Project No. 21482114

**RESPONSE TO GEOTECHNICAL PEER REVIEW COMMENTS FROM GEMTEC
PROPOSED RESIDENTIAL DEVELOPMENT
3930 AND 3960 RIVERSIDE DRIVE, OTTAWA, ONTARIO**

A geotechnical peer review was completed by GEMTEC on behalf of the City of Ottawa and the relevant comments were provided in GEMTEC Letter no. 100008.025 – Rev0, dated Dec 7, 2023. The comments are noted below with response from WSP.

Light yellow square
Name: SAND AND GRAVEL
Model: Mohr-Coulomb
Unit Weight: 20
Effective Cohesion: 0
Effective Friction Angle: 35
Phi-B: 0
Piezometric Line: 1

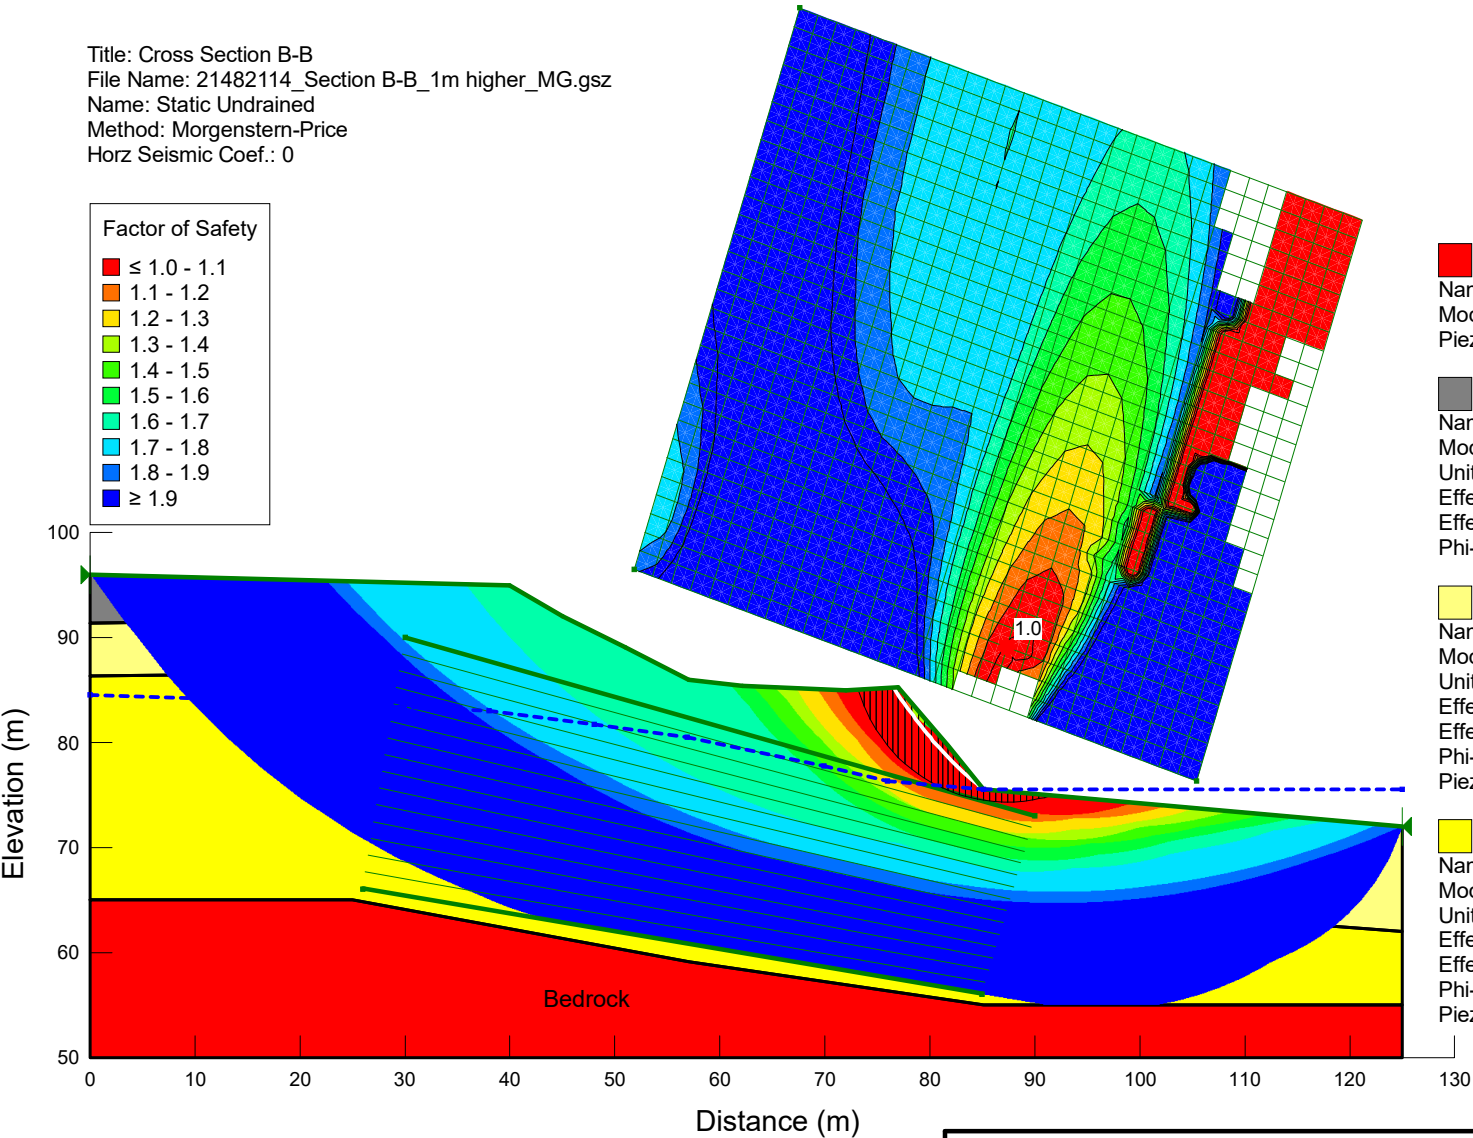
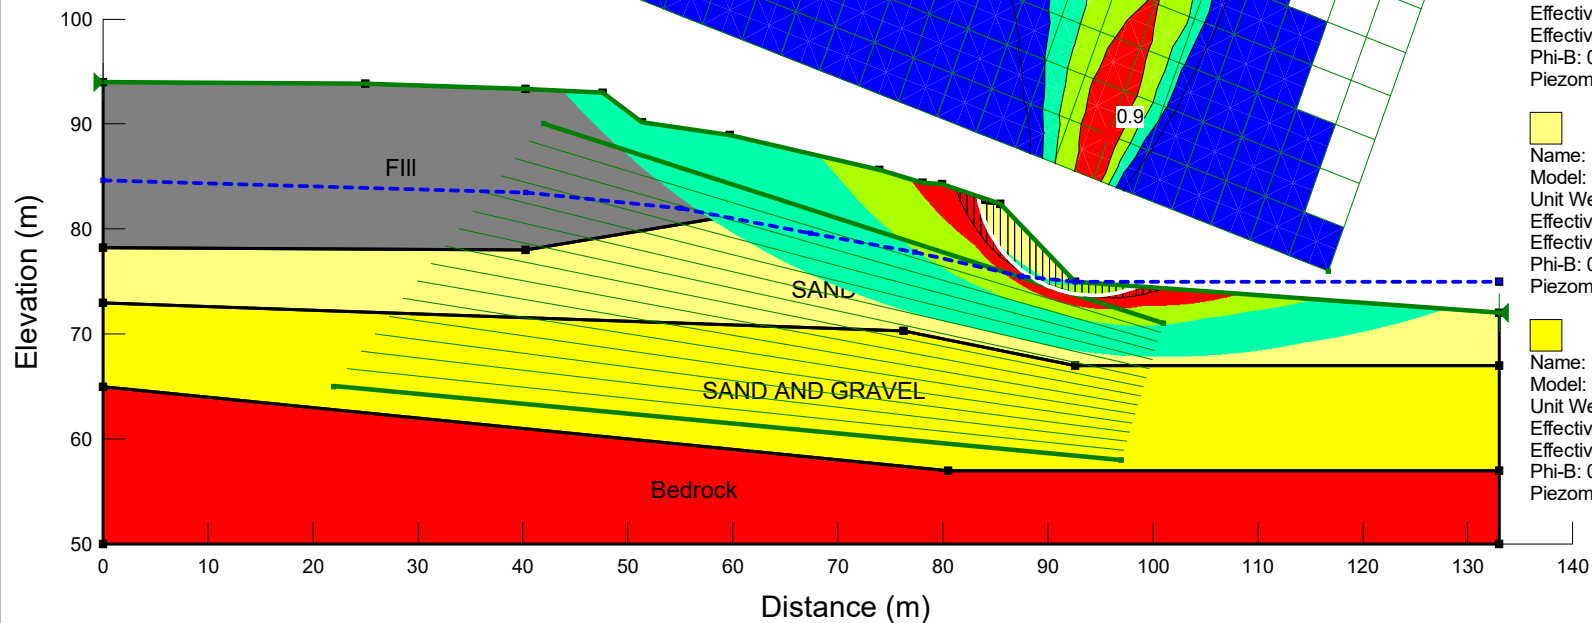
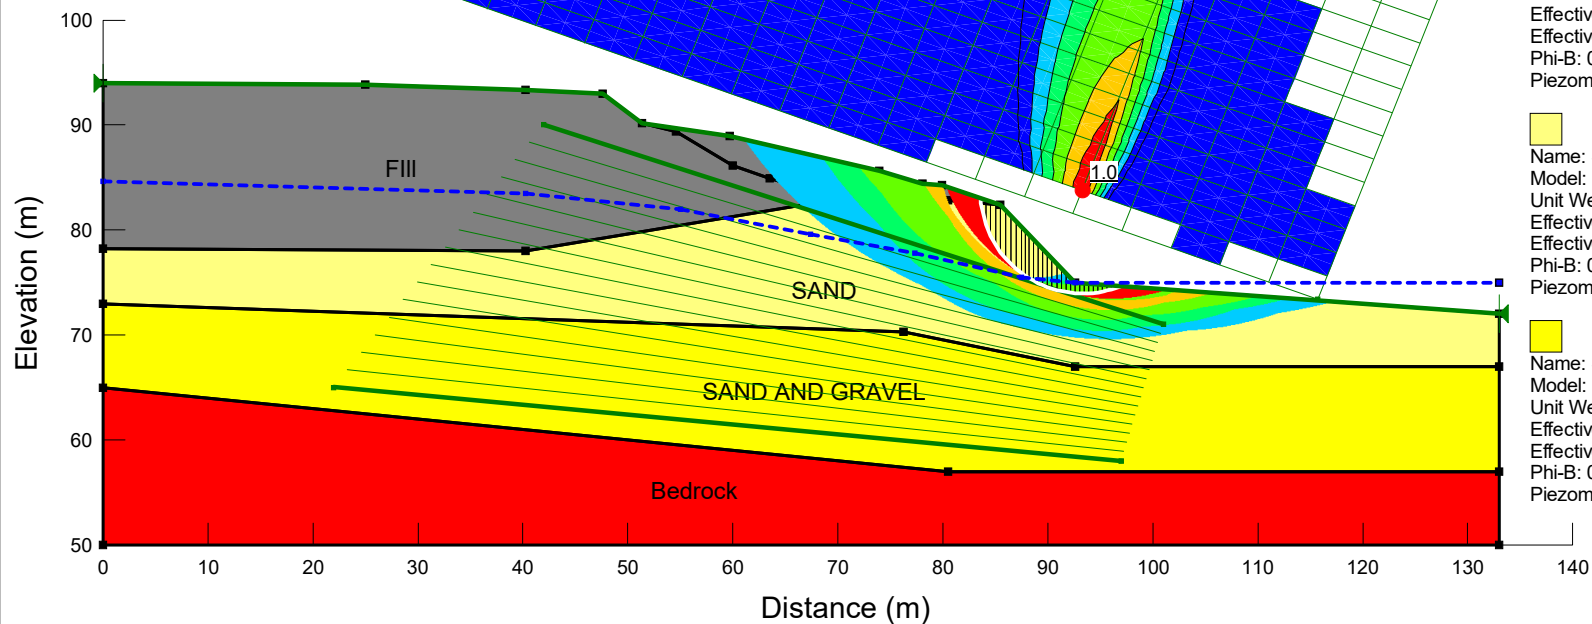
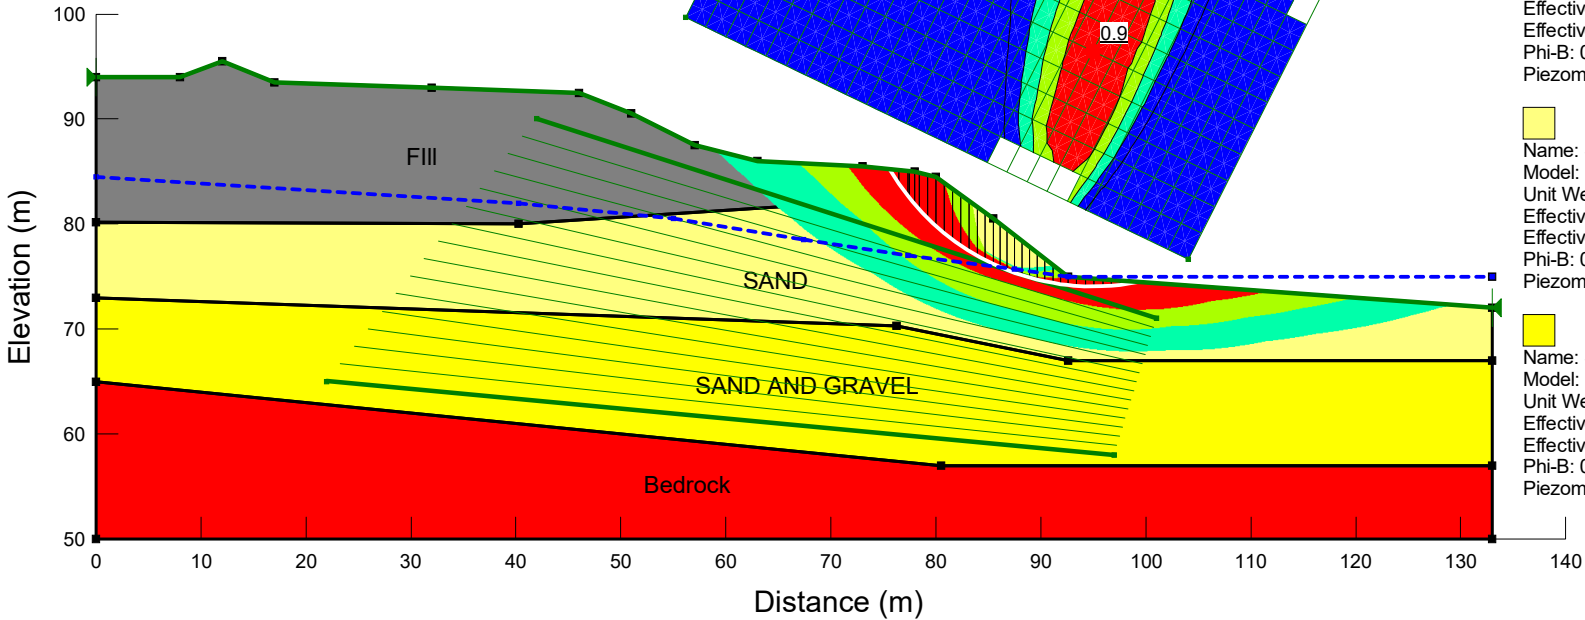
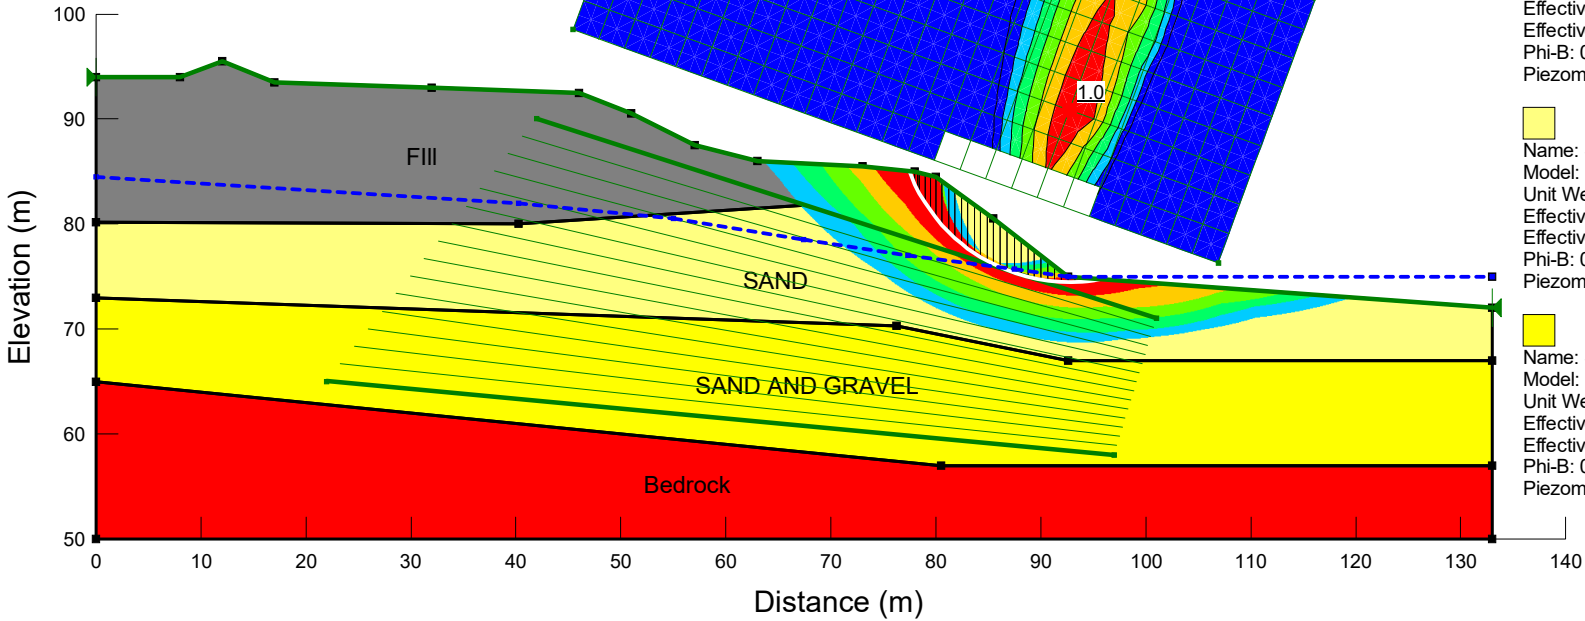
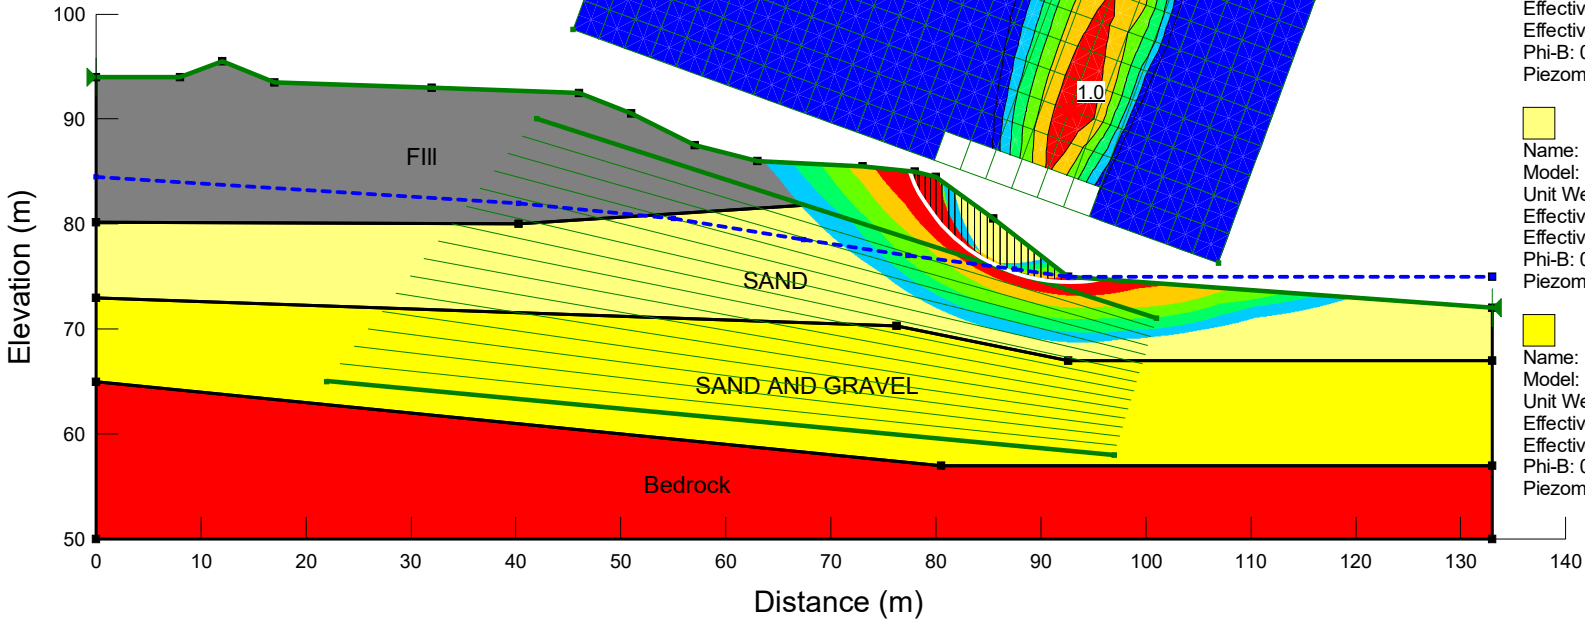
- 4) “The following comments are provided for the slope stability analysis carried out for Sections A-A', B-B', C-C', and D-D'. The safety map for the static and seismic analyses for the values of less than 1.5 and 1.1 respectively, extends past the upper edge of the point grid (for the slip circle centre), which may indicate there are slip circles with those factors of safety or less that extend horizontally farther than currently shown. This could potentially result in an increased stable slope allowance, and it is suggested that the model geometry be revised (by extending the point grid) to check the limits.”

- 5) “The groundwater level assumed in the static analyses for the South Area is at the base of the existing fill (i.e., at elevations of about 82 to 83 m) and is indicated to be based on the water levels measured in the various monitoring wells at the site. This would be Case 3 as outlined in the slope stability guidelines and may not be a realistic assumption. The fill materials above the native sands are not uniform in composition and contain cohesive layers and materials with high silt and clay contents that will tend to retain water and therefore it may not be reasonably conservative to assume the fill materials are fully drained as assumed in the slope stability analyses. The water levels summary in Section 4.1 of the report notes that: “In the South Area, the groundwater level was generally found to be between 12 to 16 m depth (i.e., between elevations of about 75 to 83 m), but as shallow as about 6 m (i.e., elevation of about 88 m).”

Response – *The models for the sections identified above were revised (by extending the point grid), no differences have been observed in the stable slope allowance.*

Response – *While the water level in the south area was recorded to be between elevations of 75.1 and 87.6 m (in monitoring wells as well as from CPT Dissipation testing), it was generally found to be below elevation of 79 m. Only one single borehole location had a higher water level of 87.6. We therefore feel that the original assumptions regarding groundwater level are reasonable assumptions for the overall groundwater depth in the area of interest. Nonetheless, as a precautionary measure and an additional check, the slope stability models for these four sections were revised to take into account for the possibility of a higher groundwater level in South Area by adjusting the piezometric line in the analysis upward in the east side of the site (where the single high level was recorded). This adjustment results in a very minor change to the slope stability (well within the margin of error of the data and assumptions which go into the analysis). The change is of sufficiently small magnitude as to make no meaningful difference to recommended stable slope allowance, and therefore we feel that the originally recommended setbacks may be maintained. The results of the revised slope stability analysis are attached to this memorandum.*
